# PREDETERMINATION SETTLEMENT AGREEMENT

CP# 09-17-70937  
HUD# 07-18-7631-8

#### **RESIDENCES AT 62W, LLC**

#### Report of Preliminary Findings:

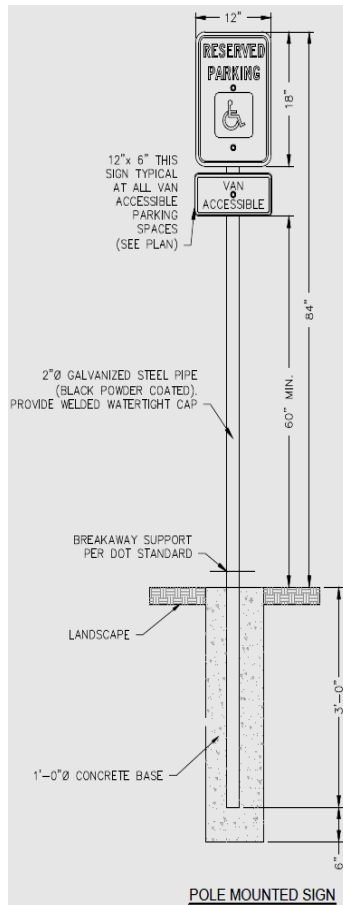
- 1) At all four parking spaces reserved for persons with disabilities to the south of the building and at the southernmost parking space located to the east of the building, the height to the bottom edge of the signage was measured at no more than 58 1/2”, which is less than the minimum height of 60 inches allowed by 2010 ADAAG.<sup>3</sup>

The plans submitted by Respondents include drawings and instructions for the installation of signage designating spaces as reserved for persons with disabilities. The relevant drawing and instructions for the installation of these signs are shown below.

Based on the drawings and instructions above, the height to the bottom edge of the signage designating the accessible parking spaces as reserved for persons with disabilities was designed to be a minimum of 60". However, as built, the heights of these signs result in their decreased visibility that makes it more challenging for persons with disabilities to readily locate these parking spaces.

- 1) R@62W will raise the signage at all four parking spaces designated as reserved for persons with disabilities as soon as the ground temperature allows.

- 1) ICRC concurs with Respondents’ proposal to reinstall the signage at the four parking spaces designated as reserved for use by persons with disabilities at a greater height as soon as the ground thaws enough to allow for this retrofit to be completed. Additionally, ICRC will require that the height to the bottom edge of the signage is compliant with the 60”- minimum height requirement, and that this modification is completed within 60 days of the date of the Closing Letter from ICRC.

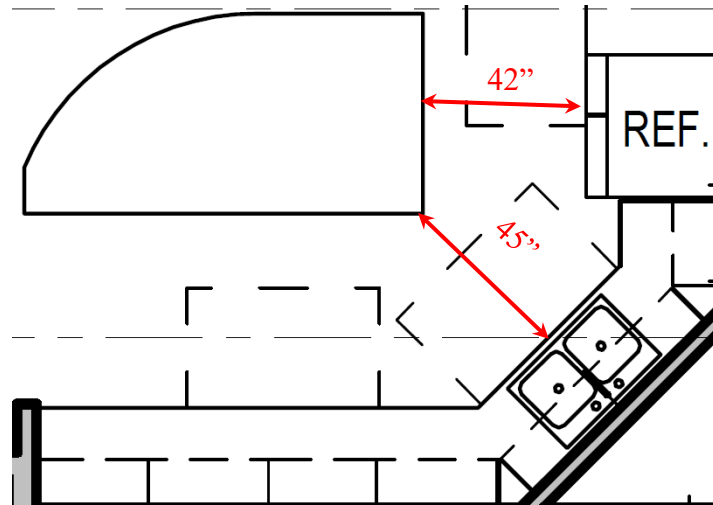
3) The common-use kitchen in the Community Room has an island. The width of the path between the island and the refrigerator was measured by the ICRC investigators at 38". The width of the path between the island and the opposing counter at the corner adjacent to the refrigerator was measured at 39 1/4".<sup>5</sup>

The plans submitted by Respondents include a scaled drawing of the kitchen in the Community Room, which shows that the width clearances of the path between the kitchen island and opposing features

were designed to be 42” at the refrigerator and 45” at the sink. These width clearances are portrayed in the captioned diagram below:

The width of the path around the kitchen island in the Community Room would have been compliant with the 40-inch minimum width if installed according to the plans. But, as built, the path is too narrow, rendering this common-use kitchen unusable by persons using wheelchairs.

- 2) R@62W will relocate the two animal waste stations closer to usable sidewalks.
- 3) R@62W and Icon will either move the refrigerator and the kitchen island further away from each other or reduce the size of the island counter to increase the clear width of the path around the kitchen to a minimum of 40”.

- 3) ICRC concurs with Respondents' proposal to either move the refrigerator and the kitchen island further away from each other or reduce the size of the island counter, so as to increase the width of the path around the kitchen to a minimum of 40".

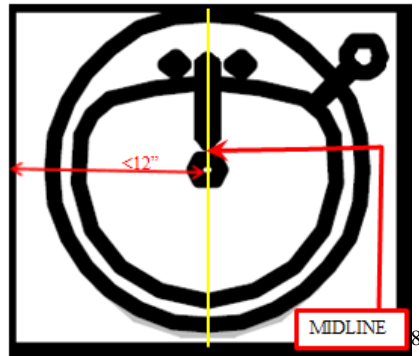
In the bathroom at the Community Room, the midline of the sink was measured to be 12 <sup>5</sup>/<sub>8</sub>" away from the nearest obstruction, which is the wall to the left of the sink.<sup>7</sup>

The plans submitted by Respondents include a scaled drawing of the bathroom in the Community Room, which shows that the midline of the sink was designed to be <12" away from the wall to the left of the sink. This dimension is portrayed in the captioned diagram at the top of the next page

- 4) Icon installed the sink in the bathroom at the Community Room based on BSB’s design. BSB has provided a revised design to Icon that will increase the distance from the midline of the sink to the adjacent wall to a minimum of 15”. Icon will retrofit the sink based on the revised design.

- 4) ICRC concurs with Respondents' proposal to reinstall the sink in the bathroom at the Community Room such that the midline of the sink is no closer than 15" to the adjacent wall.

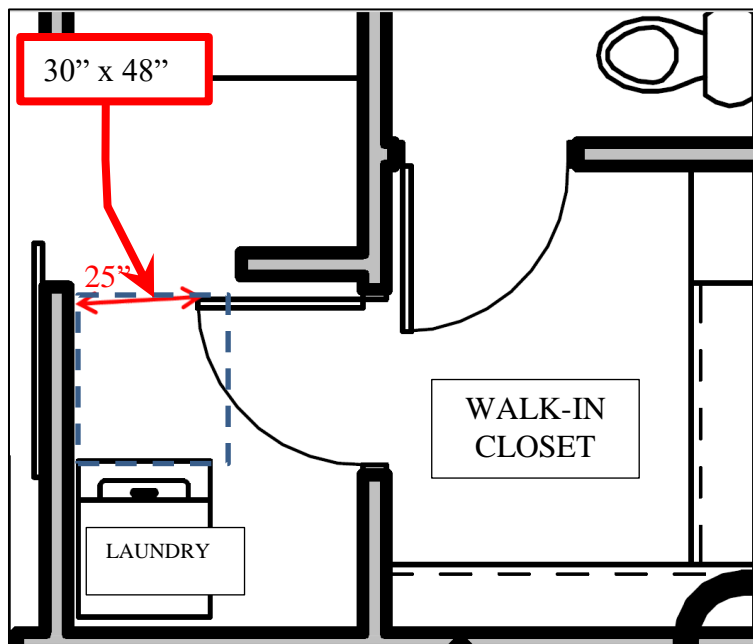
As designed and built, the sink in the bathroom at the Community Room is too close to the wall, rendering this common-use bathroom unusable by persons using wheelchairs.

(b) Respondents agree Icon will retrofit the sink at the Community Room by reinstalling the sink further away from the wall, such that the midline of the sink will be no less than 15” from the nearest obstruction as required in the Manual and ANSI 2003, for sinks with sufficient knee clearance to allow for a forward approach by persons using a wheelchair.

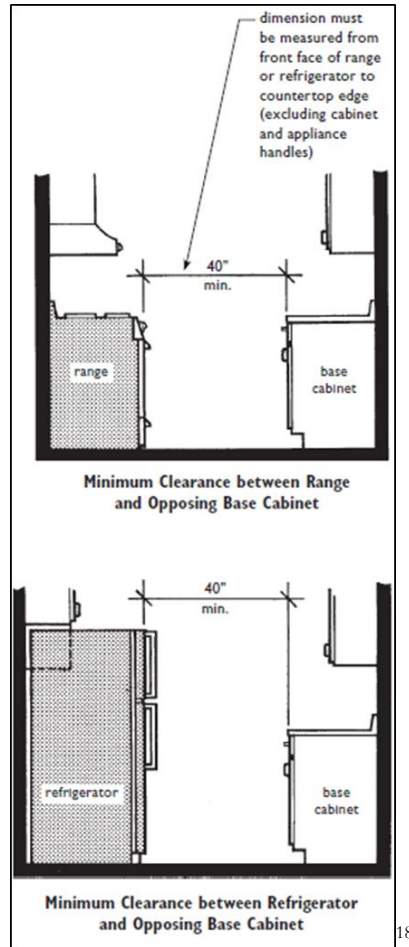
(a) The parties agree the width of the path between the kitchen island and (i) the opposing counter immediately in front of the kitchen sink and (ii) the refrigerator in the Community Room Kitchen were both measured at less than the 40”-minimum width required by the Manual and ANSI 2003.

(b) Respondents agree R@62W and Icon will increase the clear width of the path between the kitchen island and opposing features to no less than 40” in the Community Room kitchen by either moving the refrigerator and kitchen island further away from each other or by reducing the size of the kitchen island counter, to meet the 40”-minimum clear width, as required in the Manual and ANSI 2003.

(c) Respondents agree R@62W and Icon will measure the clear width of the path as indicated in the figure at the top of the next page.
